Contract #: 04-0120F4Cty: SF/ALA Rte: 80 PM: 13.2/13.9File #: 69.25B**QUALITY ASSURANCE -- NON-CONFORMANCE REPORT****Location:** Changxing Island, Shanghai, P.R. China**Report No:** NCR-000579**Prime Contractor:** American Bridge/Fluor Enterprises, a JV**Date:** 02-Jan-2010**Submitting Contractor:** Zhenhua Port Machinery Company, Ltd (ZPMC), Changxing Island**NCR #:** ZPMC-0552**Type of problem:**

Reference Description: Joint fit-up offset was observed in Segment 9BW Deck Panel Diaphragm**Description of Non-Conformance:**

NON-CONFORMANCE REPORT TRANSMITTAL

Subject: NCR No. ZPMC-0552

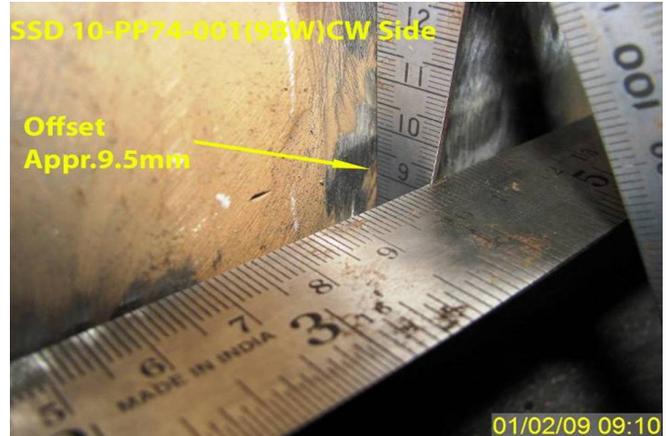
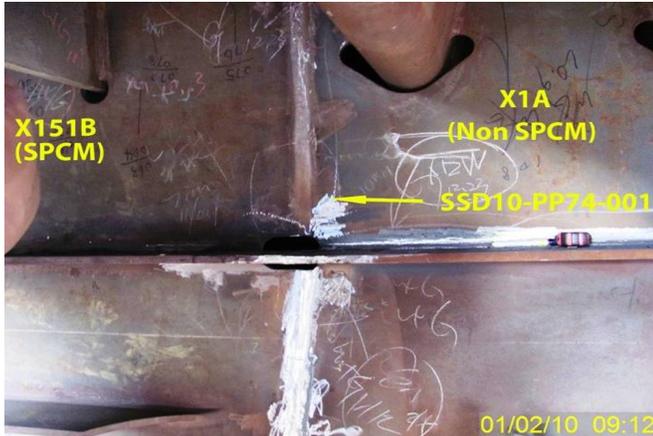
During the Quality Assurance random Visual Inspection of welds located on Orthotropic Box Girder (OBG) segment 9BW, this Quality Assurance Inspector (QA) discovered the following issues.

- One (1) area of misalignment was measured at a transition in thickness Complete Joint Penetration (CJP) butt weld.
- The weld joint is identified as SSD10-PP74-001.
- The weld joint is located in OBG segment 9BW at Panel Point (PP) 074 on the Counter Weight side.
- The Corner Assembly Web (X151B) Seismic Performance Critical Material (SPCM) plate connects to the Deck Panel Diaphragm (X1A).
- The weld joint SSD10-PP74-001 is a transition in thickness from 22mm (X151A) to 14mm (X1A).
- The misalignment/offset was measured at approximately 9.5mm. There should only be an offset of 4mm due to the transition.
- The weld joint is misaligned for 70mm along the axis of the weld.
- The maximum misalignment/offset allowed per American Weld Society (AWS) D1.5 2002 is 1.4mm (10% of the thinner part).
- The OBG Segment 9BW is located outside in front of Bay# 17.

AWS D1.5 (2002) section 3.3.3 "Parts to be joined by groove welds shall be carefully aligned. Where the parts are effectively restrained against bending due to eccentricity in alignment, the offset from theoretical alignment shall not exceed 10 percent of the thickness of the thinner part joined, but in no case shall be more than 3 mm [1/8 in.]".

Submit a repair procedure to the engineer for approval. A response for the resolution of this issue is expected within 7 days.

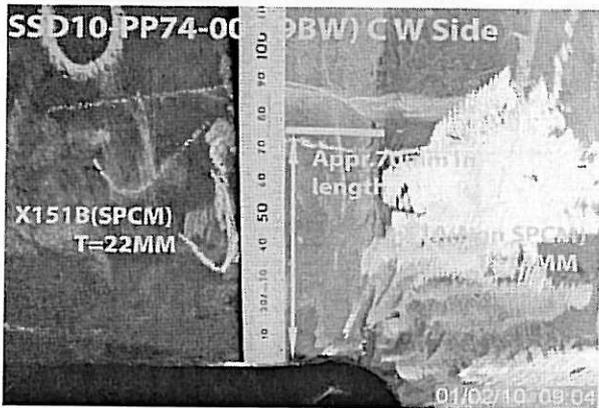
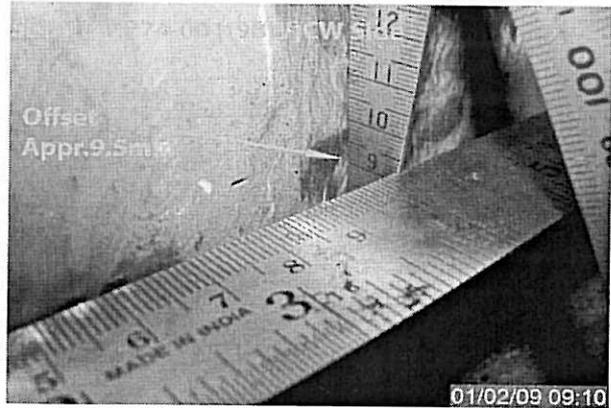
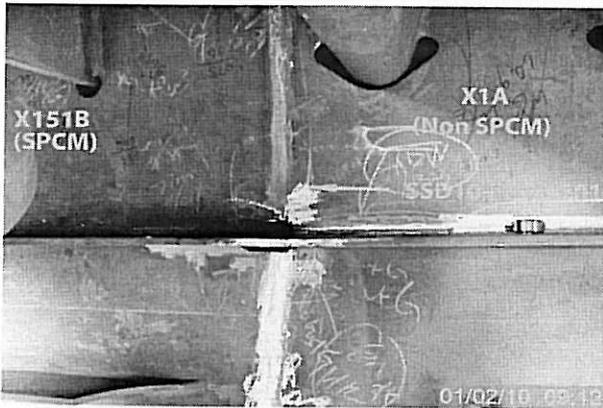
During the Quality Assurance random Visual Inspection of welds located on Orthotropic Box Girder (OBG) segment 9BW, this Quality Assurance Inspector (QA) discovered the following issues.

- One (1) area of misalignment was measured at a transition in thickness Complete Joint Penetration (CJP) butt weld.
- The weld joint is identified as SSD10-PP74-001.
- The weld joint is located in OBG segment 9BW at Panel Point (PP) 074 on the Counter Weight side.
- The Corner Assembly Web (X151B) Seismic Performance Critical Material (SPCM) plate connects to the Deck Panel Diaphragm (X1A).
- The weld joint SSD10-PP74-001 is a transition in thickness from 22mm (X151A) to 14mm (X1A).
- The misalignment/offset was measured at approximately 9.5mm. There should only be an offset of 4mm due to the transition.
- The weld joint is misaligned for 70mm along the axis of the weld.
- The maximum misalignment/offset allowed per American Weld Society (AWS) D1.5 2002 is 1.4mm (10% of the thinner part).
- The OBG Segment 9BW is located outside in front of Bay# 17.

AWS D1.5 (2002) section 3.3.3 "Parts to be joined by groove welds shall be carefully aligned. Where the parts are effectively restrained against bending due to eccentricity in alignment, the offset from theoretical alignment shall not exceed 10 percent of the thickness of the thinner part joined, but in no case shall be more than 3 mm [1/8 in.]".

Draft of welding discontinuity:

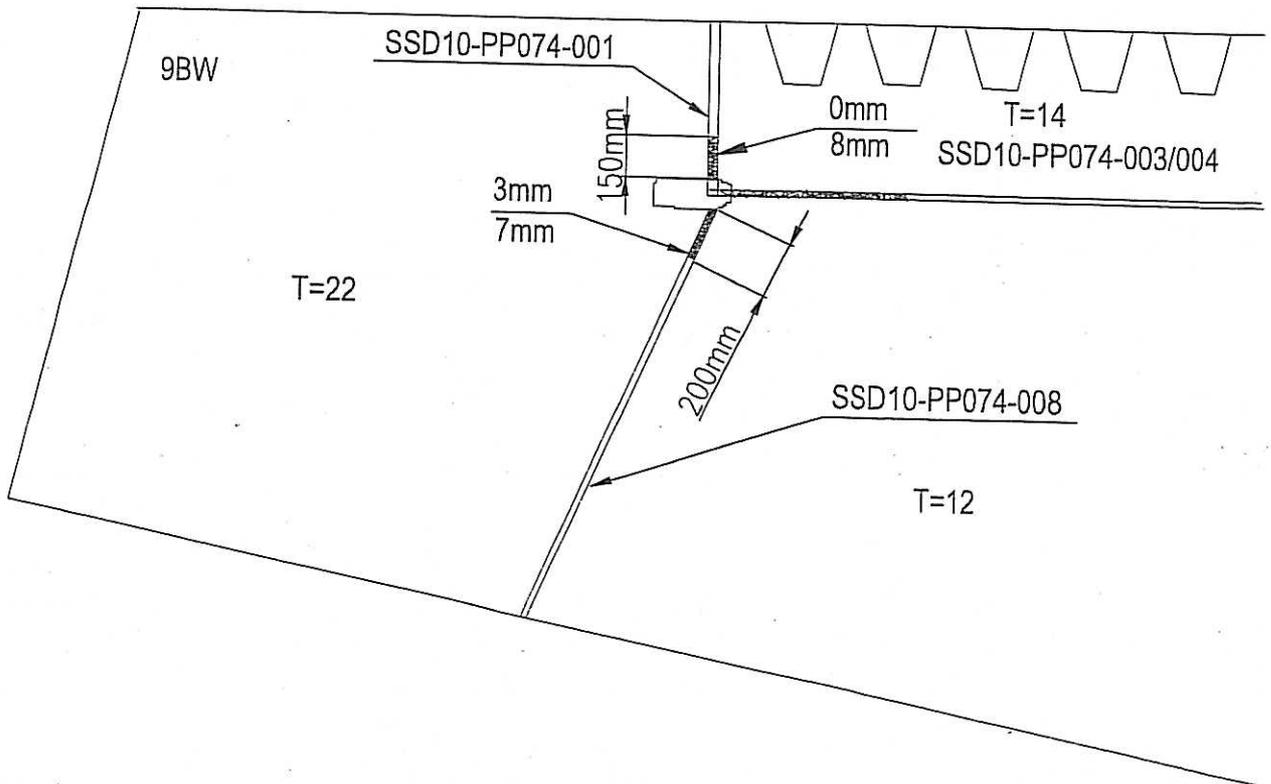
After inspection corner assembly diaphragm and deck plate connect plate overhand weld, it was 8mm misalignment, 150mm in length, weld ID: SSD10-PP074-001 SSD10-PP074-008, relevant weld ID: SSD10-PP074-003/004.

Weld distortion and fabricate error.

1. Remove a portion from butt weld SSD10-PP074-001(length: L1) and a portion from butt weld SSD10-PP074-008(length: L2), and a portion from fillet weld SSD10-PP074-003/004 and weld in bottom side of flange including near side and far side (namely weld FB011-PP074-003/004) in the same area (length: L3) by flame cutting or gouging. The length L1, L2 and L3 will be decided according to actual situation. Preheat according to the WPS prior to gouging.

2. Prepare the excavations according to the relevant WPS.
3. Adjust diaphragm and FB11B to make the misalignment meet the tolerance by external force. Tack weld the items.

4. Preheat and weld SSD10-PP074-001 and SSD10-PP074-008 according to repair WPS.
5. Check the misalignment after welding, if it is acceptable, preheat and weld SSD10-PP074-003/004 and FB011-PP074-003/004.

6. Grind the welds above flush to the adjacent weld or base metal.
7. Check the weld with relevant NDT according to the work drawings.

Note: If gap of butt weld exceeds the tolerance, steel backing can be used in the process of welding, and remove the steel backing after welding.
